188 Beaumont Street Fast-track

Section 67 request to applicant

Fast-track – information gaps under s67

Application number(s):	BUN60464683 LUC60464684 WAT60464685 DIS60464686 SUB60464687
Applicant:	Westhaven Residential Limited Partnership
Address:	188 Beaumont Street, Auckland Central (Wynyard Quarter)
Proposed activity(s):	Substantive fast-track application for a marker building containing 210 residential apartments, ground floor retail activities and associated car parking.

Figure 2: Morning Peak network effects

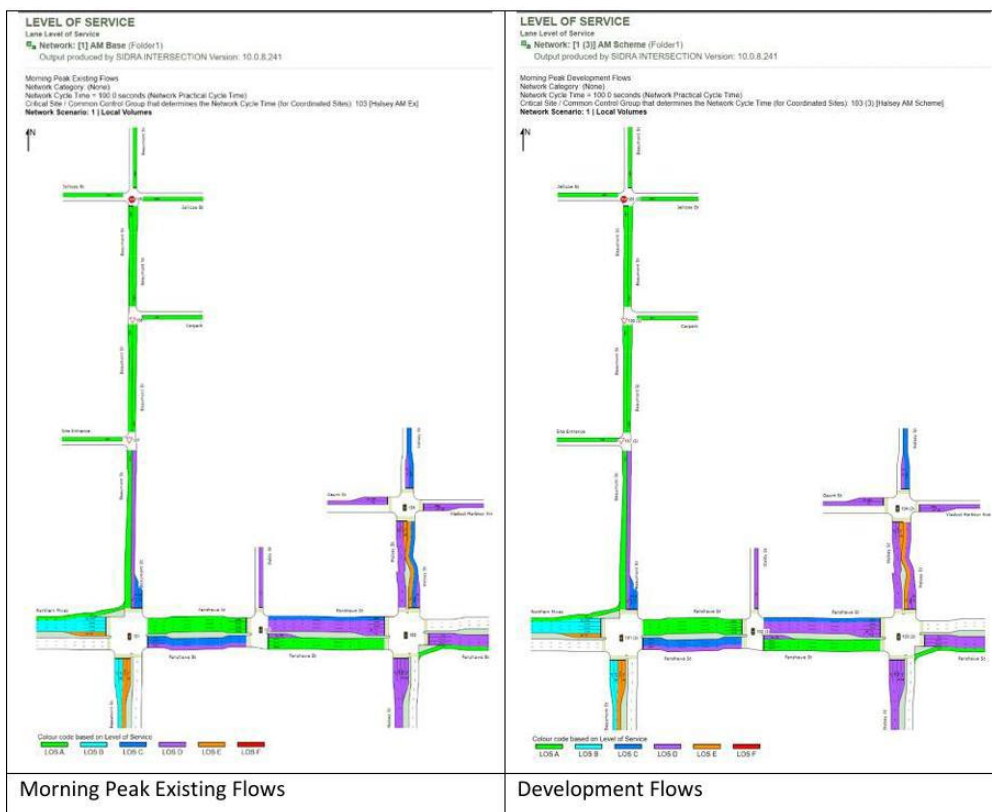
- I. **Traffic survey details** – It is recommended that you provide an updated traffic survey so that the assessment reflects current traffic conditions within the surrounding environment.
- II. **SIDRA model network level report** – SIDRA modelling was undertaken to assess changes in Level of Service (LOS) at a network level. The results indicate an increase in delay on Halsey Street south of Viaduct Harbour Drive during the AM peak, and a change in LOS on Halsey Street north of Viaduct Harbour Drive during the PM peak compared to the baseline, as shown below. This change is expected given the scale of the proposed development. However, the ITA does not include the detailed SIDRA modelling output required to verify the input data or assess changes in average delay, speed, queue length, and potential impacts on PT services.

Please provide a SIDRA network model report to better understand the extent of changes in queue length and average delay to understand the effects determined at a network level.
